ADDENDUM #1 – REVISIONS TO THE CONTRACT DOCUMENTS
Grand Junction VA Medical Center PM&RS and Prosthetics Center

ADDENDUM #1 – REVISIONS TO THE CONTRACT DOCUMENTS

P. DEDUCT ALTERNATE NO. 14: Delete Landscaping.

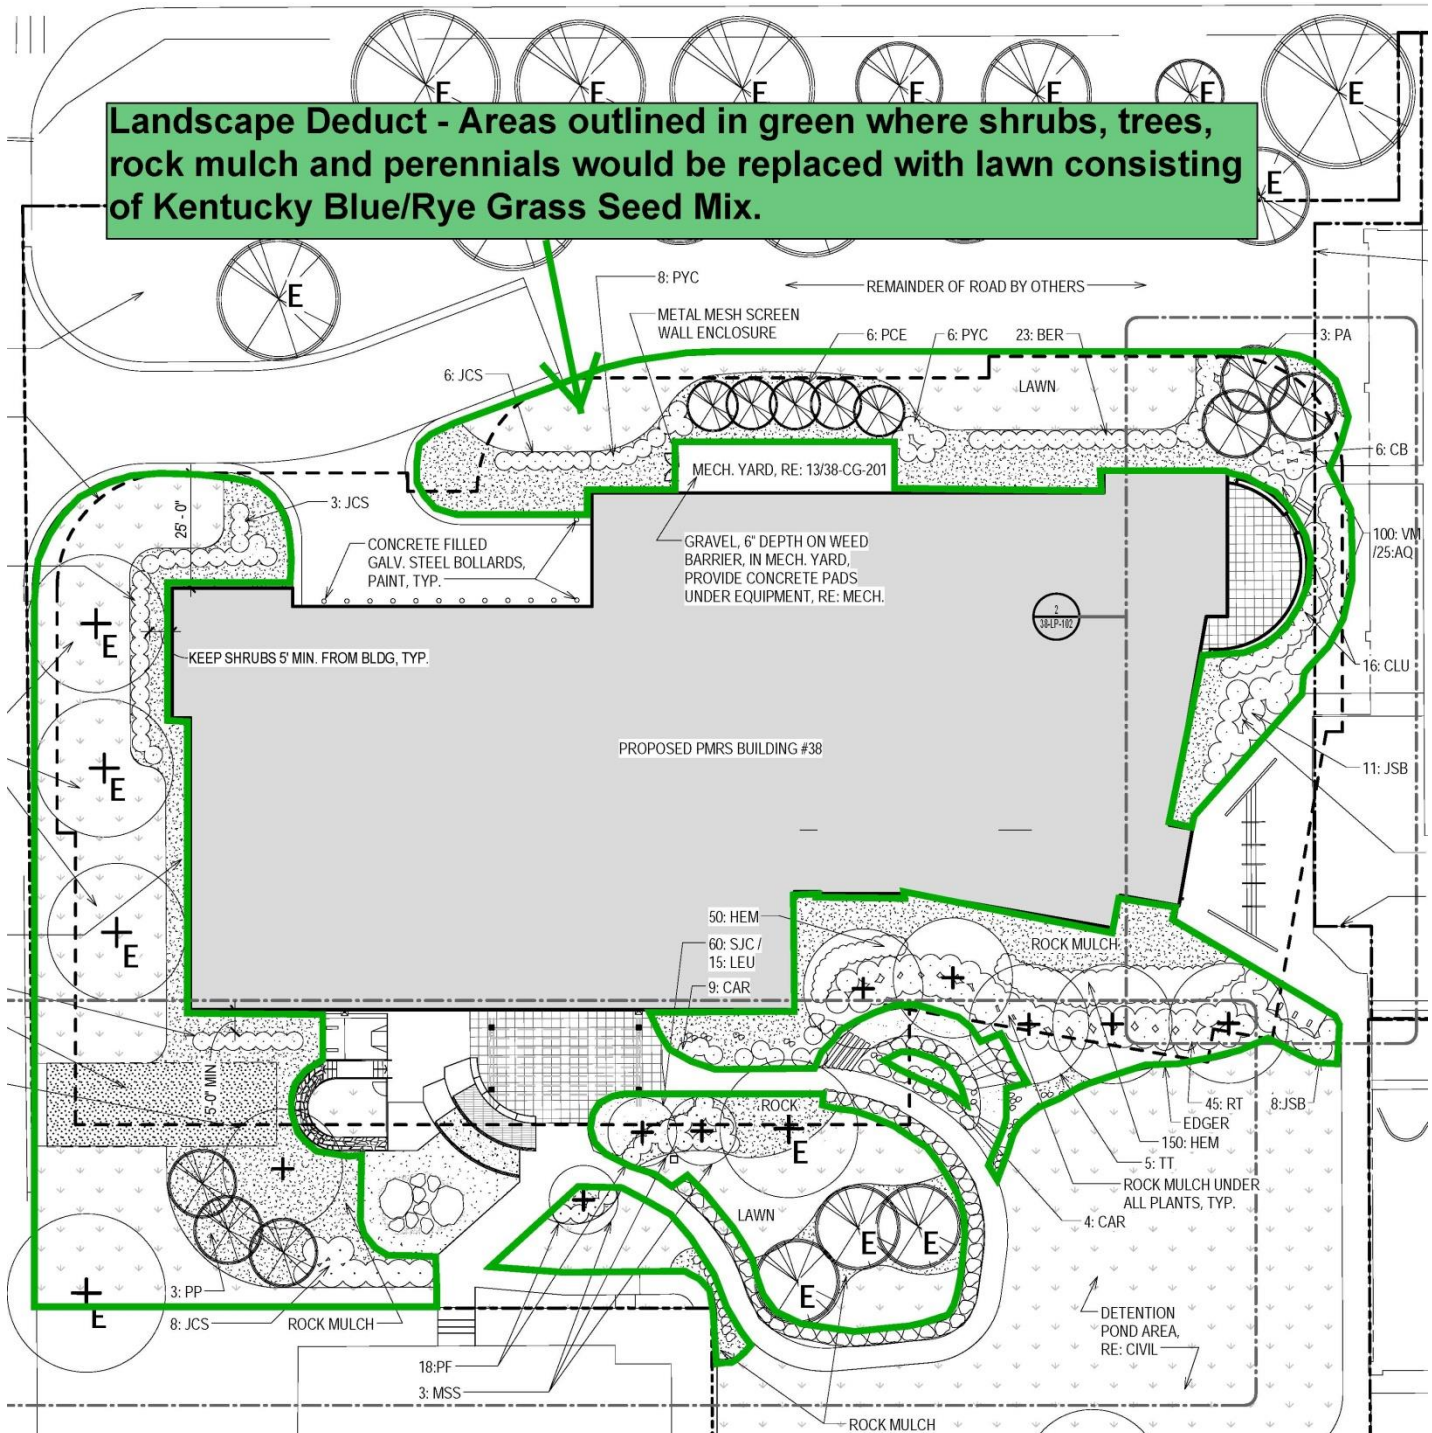
Item 1. Deduct Alternate Delete Landscaping

Delete all landscape shrubs, trees, rock mulch and perennials and replace with lawn consisting of Kentucky Blue/Rye Grass Seed Mix. For further clarification, see delineation that follows:

Sheet 38-CU-101

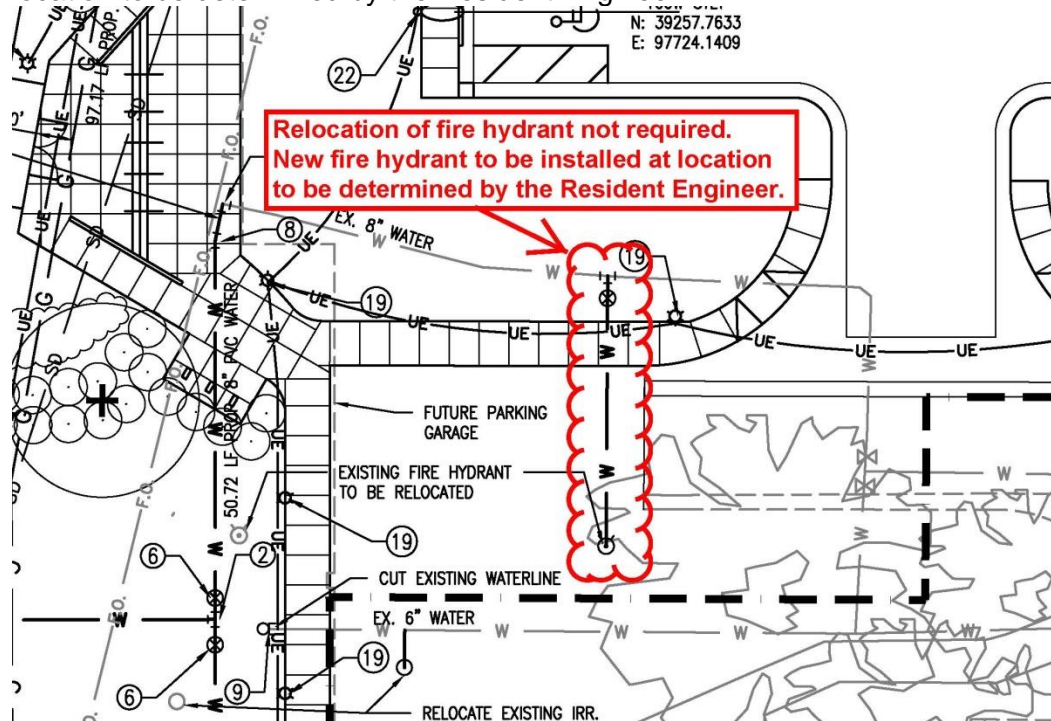
Item 17. Delete Fire Hydrant Relocation/Add New Fire Hydrant

Delete relocating fire hydrant at location as shown in sketch below. Install new fire hydrant at location to be determined by the Resident Engineer.

Sheet 38-CU-101

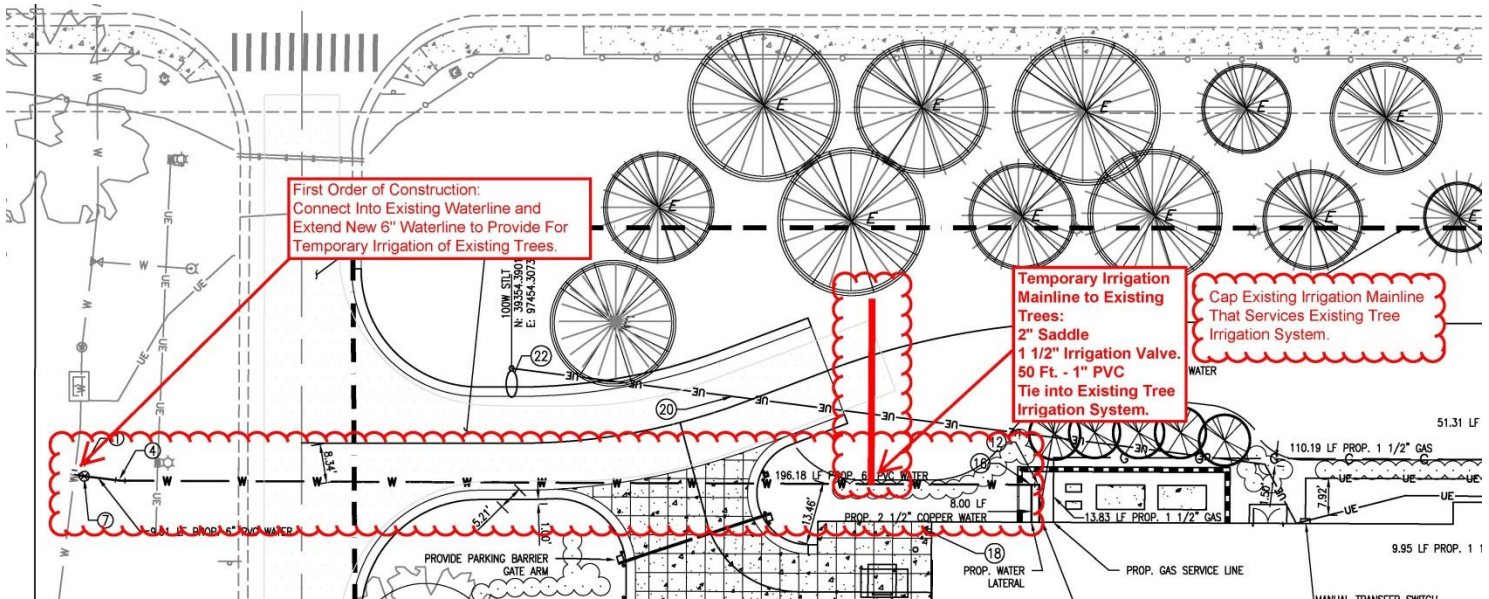
Item 18: Provide Temporary Irrigation to Existing Trees

Revise sheet to include notes in sketch below to provide temporary irrigation to existing trees during construction.

FIRST FLOOR - FLOOR GRILLE DIMENSIONS

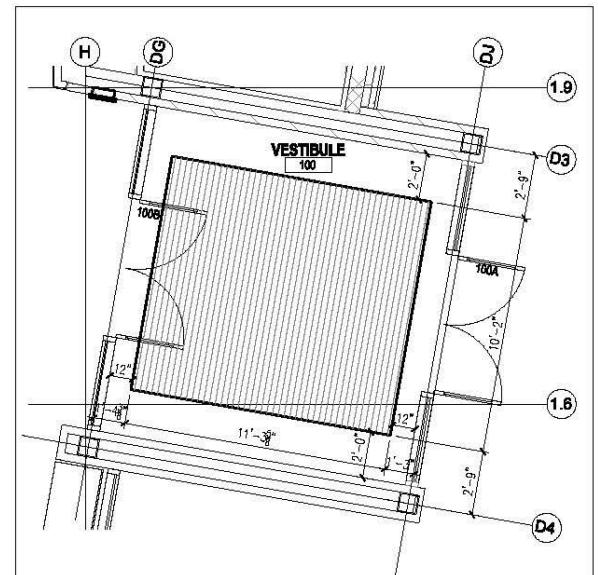
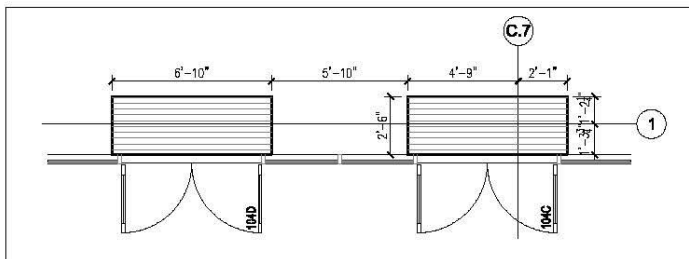
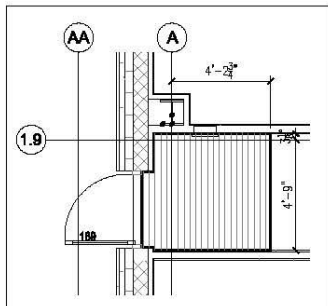
Item 23: Floor Grille Dimensions

Add the following floor grille dimensioning details:

1 CHECK-IN COUNTER SECTION

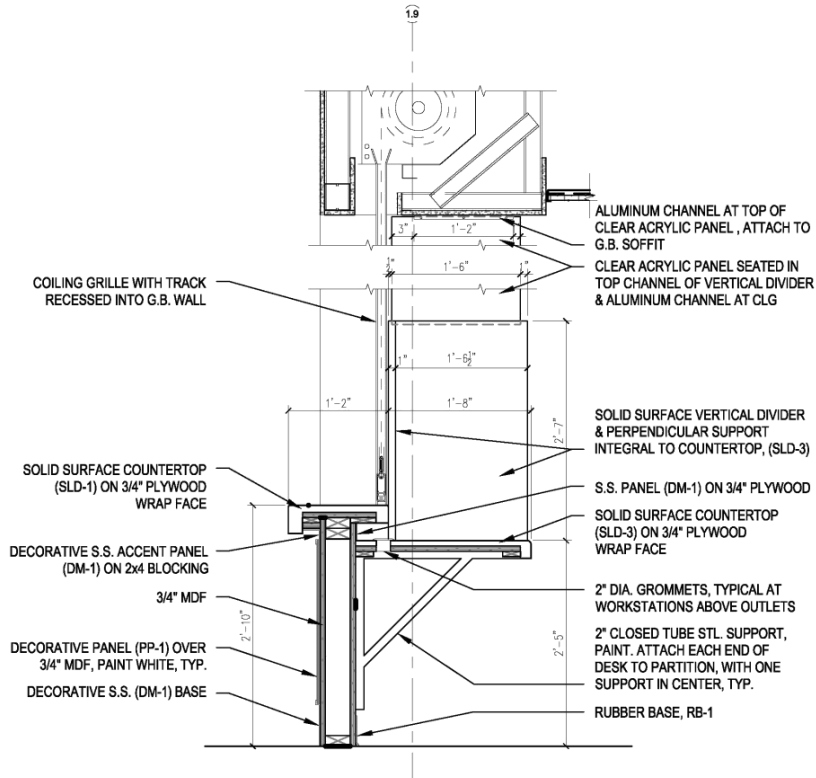
Item 27: Divider to Check-In Counter

Add a solid surface vertical divider and perpendicular support integral to the countertop to the check-in counter (room 155) per the following drawings:

PLAN DETAIL - COILING GRILLE AT CHECK-OUT COUNTER

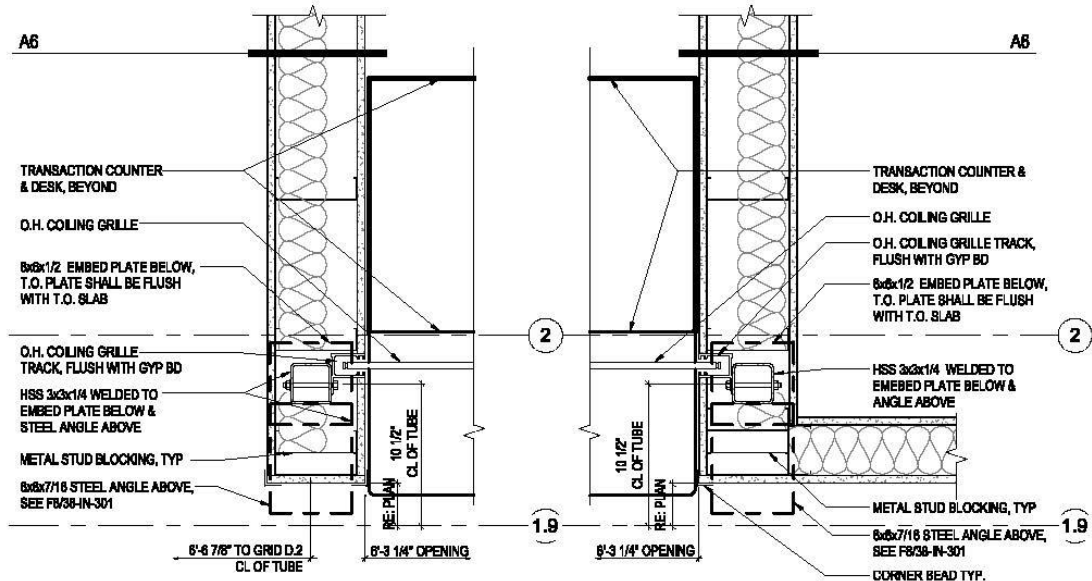
Item 29: Revise Coiling Grille at Check-In Counter

Revise details F1, F2, F3, F4 per the following drawings:
